AMENDMENTS TO THE DRAWINGS

FIG. 4

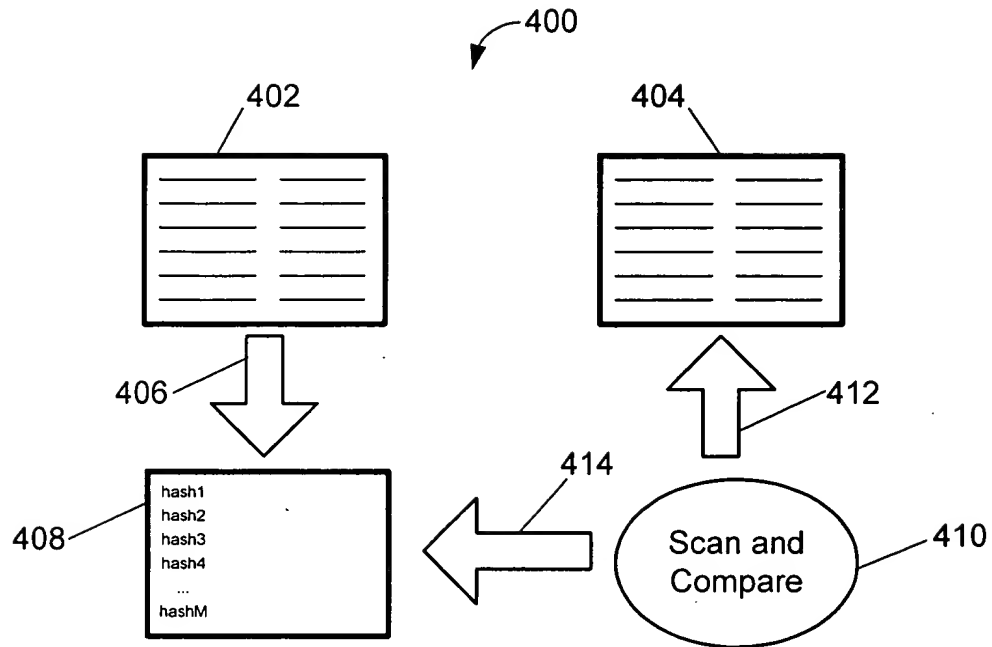
The drawings are objected to because they fail to show necessary textual labels of features or symbols in Figs. 4 and 5 as described in the specification. For example, placing a label, "hash join mechanism," with element 400 of Fig. 4, would give the viewer necessary detail to fully understand this element at a glance. A descriptive textual label for each numbered element in these figures would be needed to better understand these figures without substantial analysis of the detailed specification. Any structural detail that is of sufficient importance to be described should be labeled in the drawing. Optionally, the applicant may wish to include a table next to the present figure to fulfill this requirement. See 37 CFR 1.83. 37 CFR 1.84(n)(o), recited below:

Applicant respectfully submits replacement drawings for Figures 4, 5, and 6.

400	Hash Join Mechanism
402	Left Table
404	Right Table
406	Hash Algorithm
408	Hash Table
410	Compare Operator
412	Scanning
414	Probing
